UNITED STATES PATENT AND TRADEMARK OFFICE

APPLICATION NO.	FILING DATE	FIRST NAMED INVENTOR	ATTORNEY DOCKET NO.	CONFIRMATION NO.
10/721,082	11/26/2003	Masahiro Kiyotoshi	04329.3186	7869
22852	7590	08/05/2005	EXAMINER	
FINNEGAN, HENDERSON, FARABOW, GARRETT & DUNNER LLP 901 NEW YORK AVENUE, NW WASHINGTON, DC 20001-4413			LEE, EUGENE	
			ART UNIT	PAPER NUMBER
			2815

Office Action Summary

DETAILED ACTION

Fig. 5B

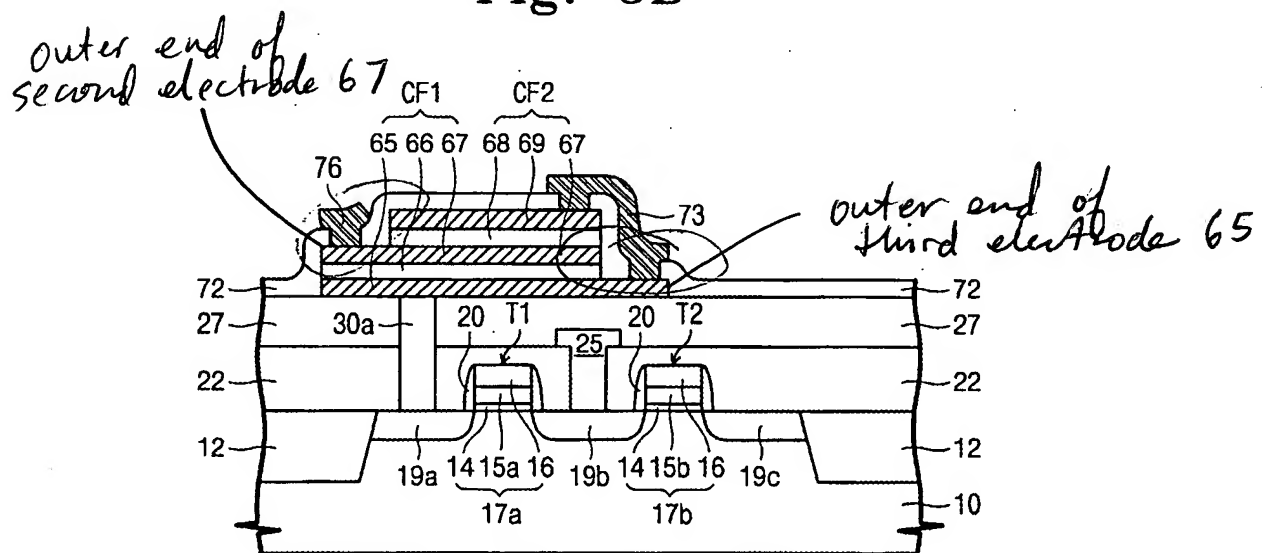
2. Claims 1, 6, and 7 are rejected under 35 U.S.C. 102(e) as being anticipated by Kim 6,617,628 B2. Kim discloses (see, for example, Fig. 5B) a ferroelectric memory device comprising a semiconductor substrate 10, stack capacitor (capacitor structure) comprising an upper electrode layer (first electrode) 69, middle electrode layer (second electrode) 67, lower electrode layer (third electrode) 65, ferroelectric layer (first dielectric film) 68, ferroelectric layer (second dielectric film) 66, insulating layer (insulating film) 72, first hole, second hole, third hole, metal interconnection (first conductive connection) 73, and plate line (second conductive connection) 76.

Regarding the limitation “wherein an outer end of the second electrode is entirely positioned outside the first electrode in a direction parallel to a main surface of the semiconductor substrate and an outer end of the third electrode is entirely positioned outside the second electrode in the direction parallel to the main surface of the semiconductor substrate”, see, for example, FIG. 5B wherein Kim discloses left end (outer end) of middle electrode layer 67 being positioned outside the upper electrode layer 69; and the right end (outer end) of lower electrode layer 65 being positioned outside the middle electrode layer 67.

Regarding the applicant's argument on page 8, first and second paragraphs of the amendment filed 7/15/05 that Kim fails to teach or suggest "an outer end of the second electrode is entirely positioned outside the first electrode" and further Kim also fails to disclose the claimed "outer end of the third electrode is entirely positioned outside the second electrode" because the right end of middle electrode 67 is not positioned outside upper electrode 69, and the left end of lower electrode 65 is not positioned outside middle electrode 67, this argument is not persuasive. Even though the right end of middle electrode is not positioned outside upper

electrode, and the left end of lower electrode is not positioned outside middle electrode, these are not the only ends of the middle electrode and the lower electrode. The middle electrode and lower electrode also have a left end and right end respectively, and these ends clearly show the outer end (left end) of the second electrode 67 being entirely positioned outside the first electrode 69, and further the outer end (right end) of the third electrode 65 being entirely positioned outside the second electrode 67. Please see figure below.
